Addendum No. 2

Date: July 30, 2024
Project: EHES Media Center Renovation
Project #: IN24004
Bid Date: August 6, 2024

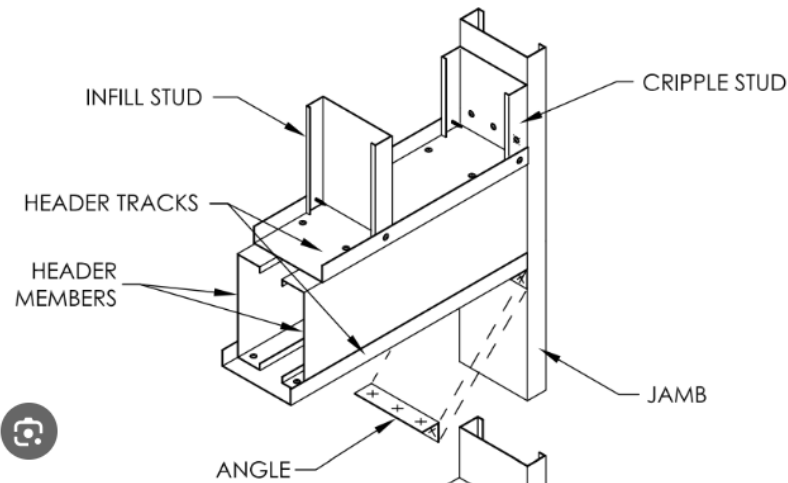
6. **Question:** In the spec book 9 21 16 / Section 3.2 – D, I totally get the 16ga jam studs, then it says “no less than double stud at the head and jams. Does this need to be a 16ga boxheader?

Answer: Yes - this needs to be a steel stud box header, sketch similar to below:
